Public Comment reg. Public Hearing about Coastal Development Permit 3-20 (CDP 3-20)
item 6a Planning Commission 4-14-2021

PUBLIC COMMENT RE CDP 3-20

Re: Caltrans ADA project (CDP 3-20) comment

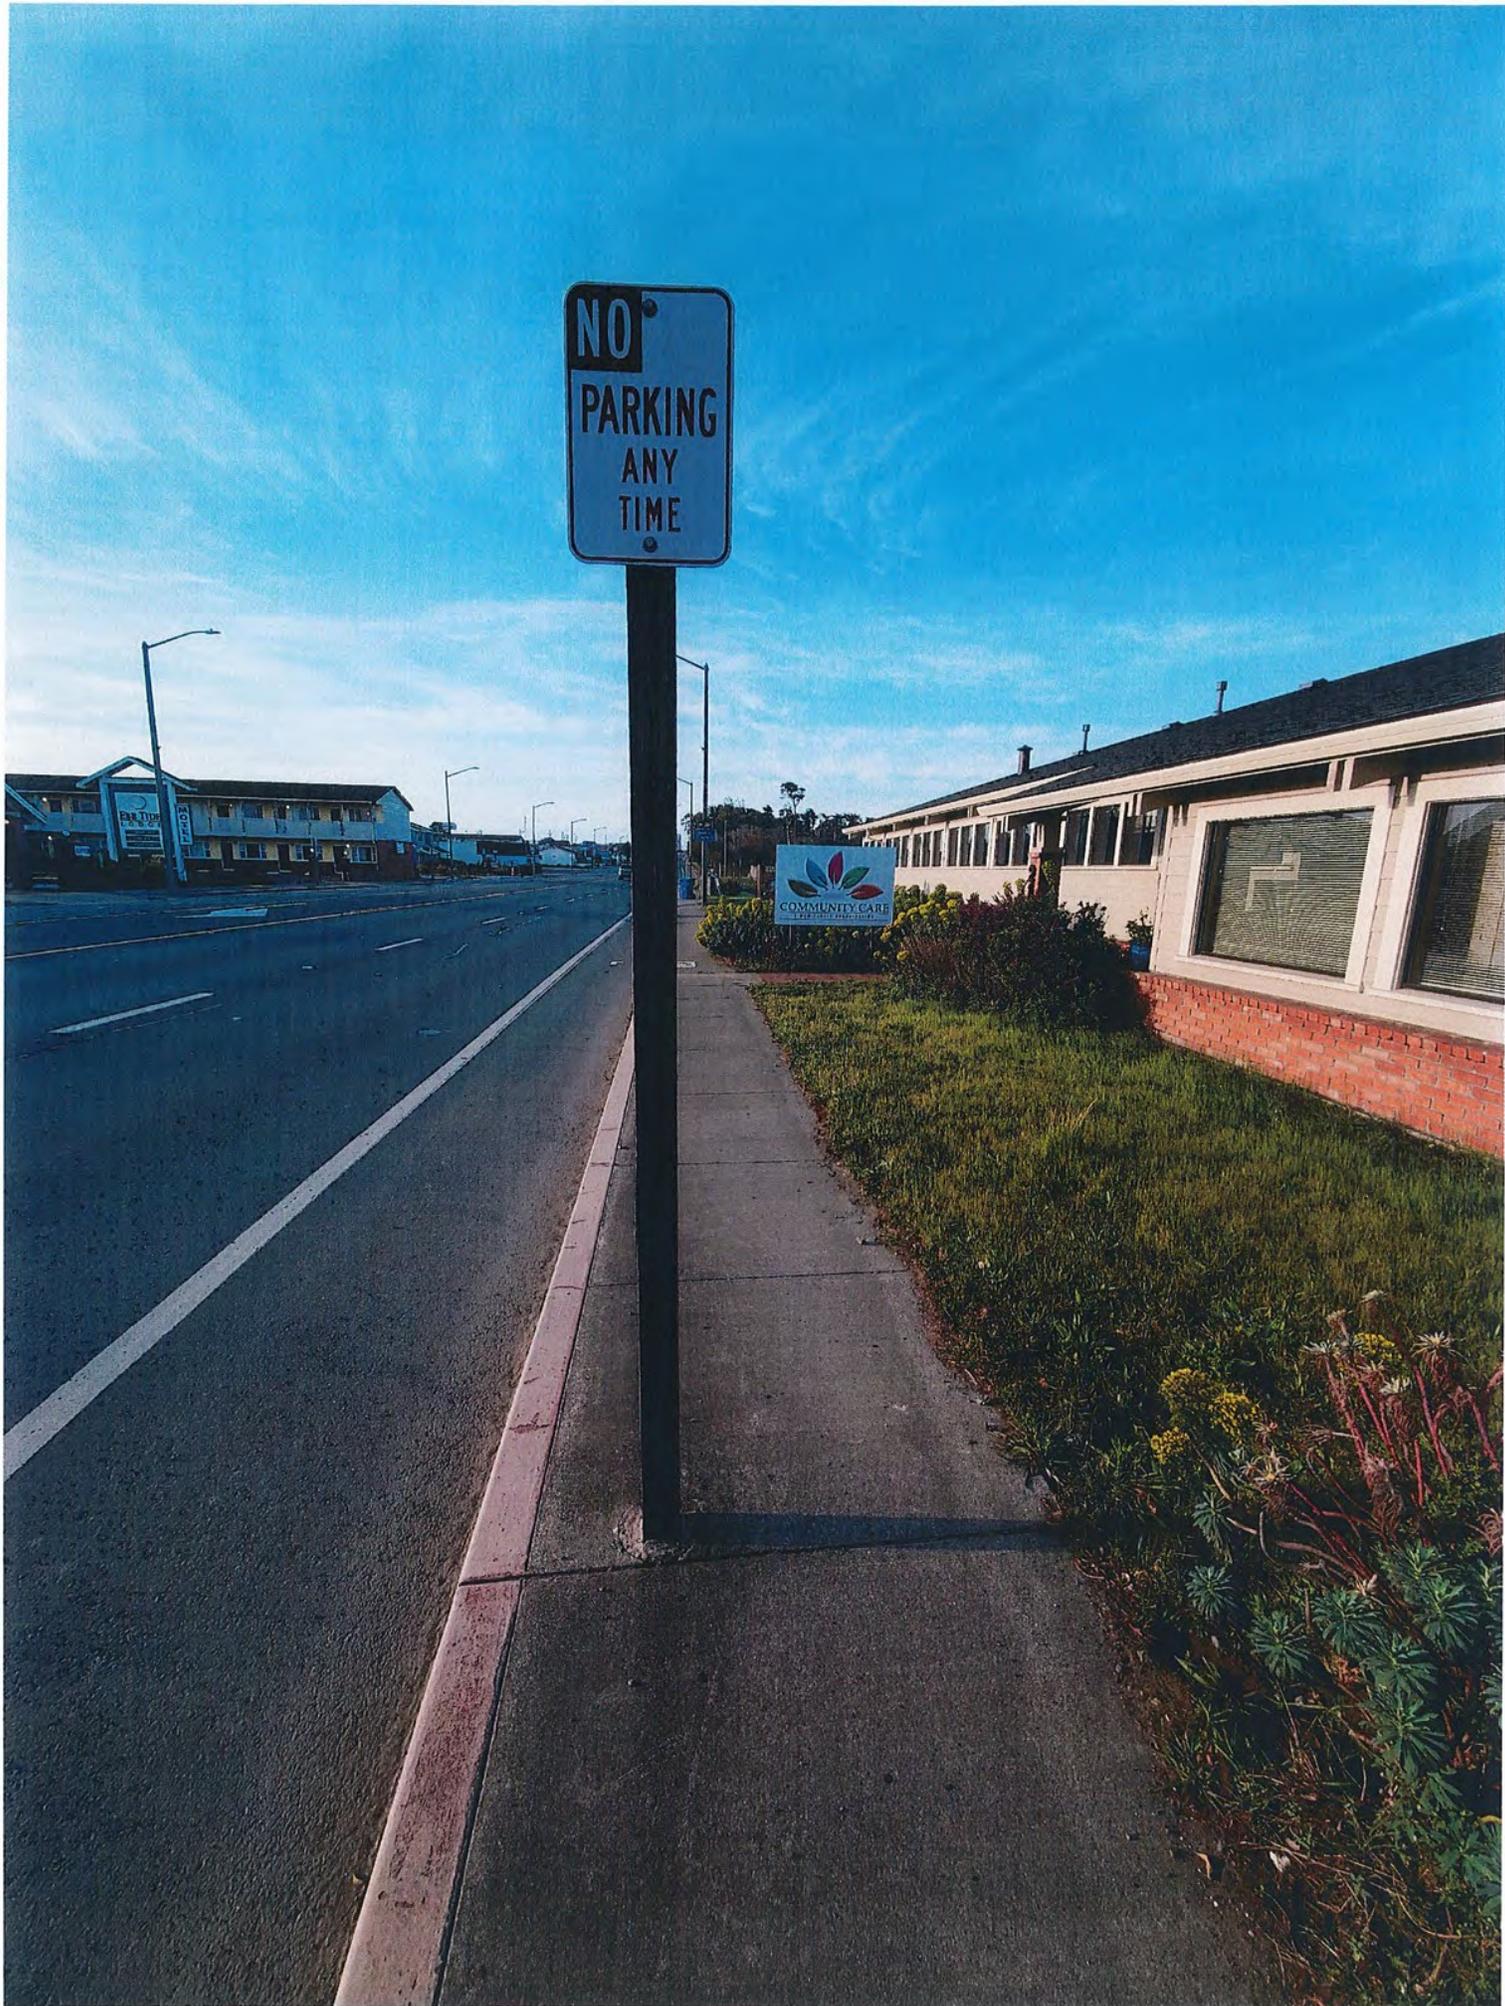
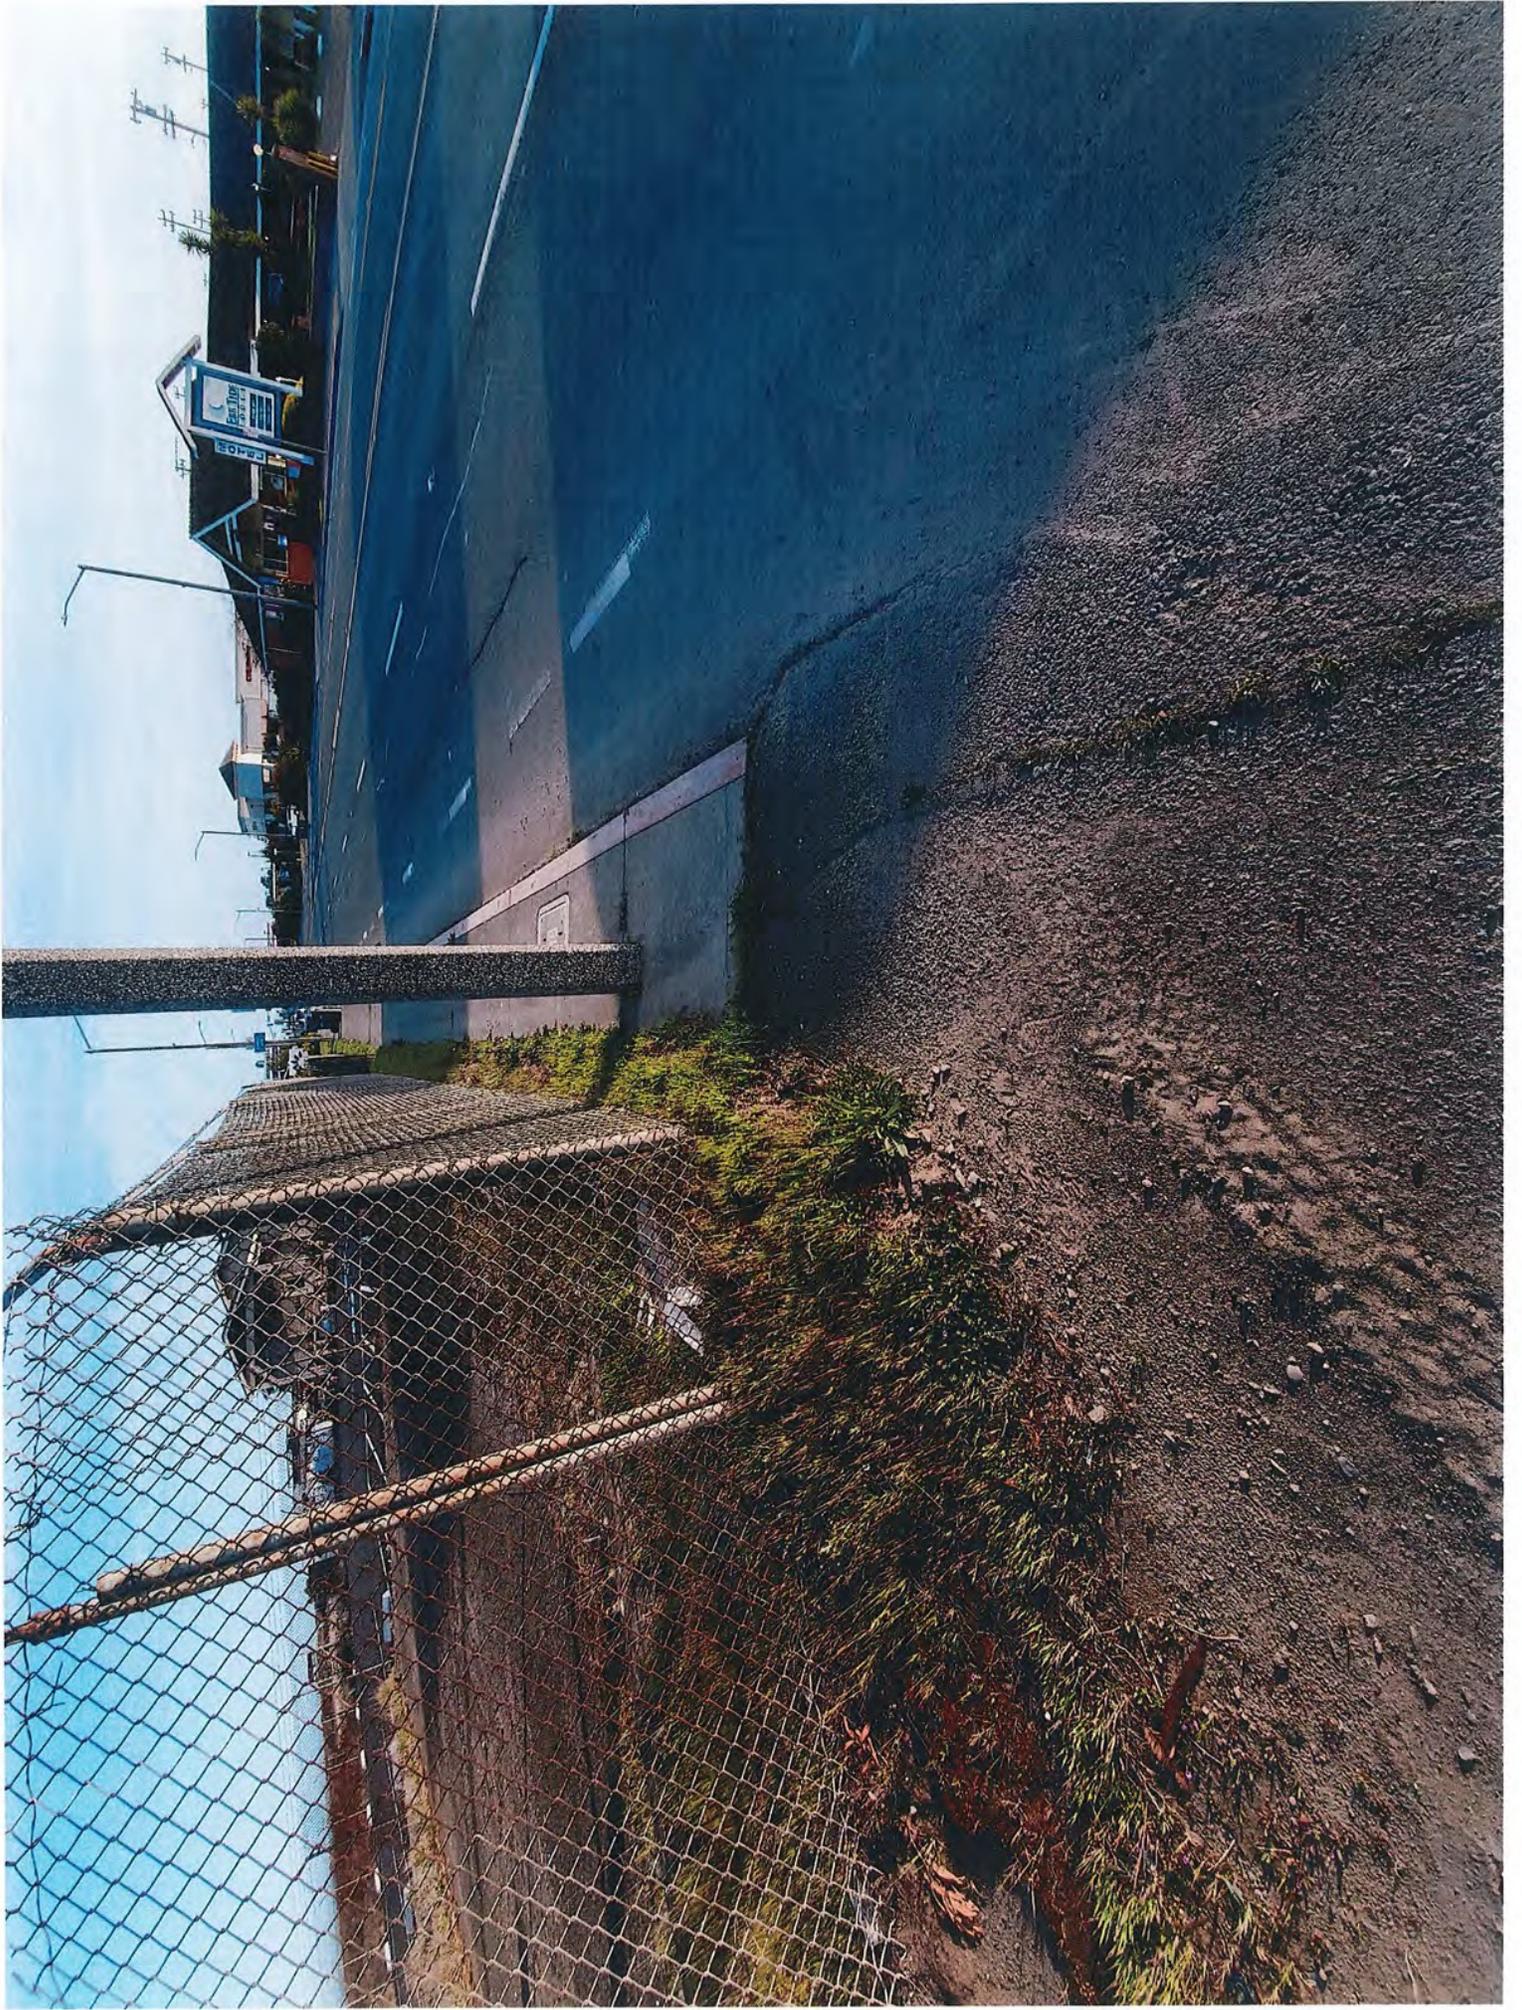
The 24 enclosed photos taken this morning show the current conditions of the Caltrans right-of-way along the west side of Highway One starting at Oak Street and heading south towards Maple Street.

is the sidewalk along the western side of Highway One south of Oak Street and north of Maple streets where numerous signs are in the middle of the sidewalk and far less than 48" inches of clearance is available. In the least, the signs in the sidewalk should be relocated to the curb itself and holes for the relocated poles should be patched so the sidewalks provide the required width of travel free from obstructions.

The existing conditions are quite dangerous and require numerous crossings of Highway One in order for people with mobility impairments to be able to use the travel paths without having to operate wheelchairs or scooters in the parking lanes of the street. The conditions after the project are improved in many places but the lack of relocation of the existing signs blocking fully accessible widths of sidewalk segments does not correct the existing deficiencies even after the proposed project will be implemented. The existing intersections allowing safer access to the sidewalks on the eastern side of the Highway One right-of-way are too far from some of these sidewalk segments and there is no signage at those intersections offering crossing opportunities to alert mobility-impaired people they should cross now rather than continuing on their existing travel path, which will be obstructed by the sign poles and deficient driveway aprons and curb cuts. In order to meet ADA requirements and to be consistent with applicable general plan policies, the project should be expanded to include removing or relocating all existing obstructions that prevent a full 48" of accessible travel paths along both sides of the Highway One right-of-way.
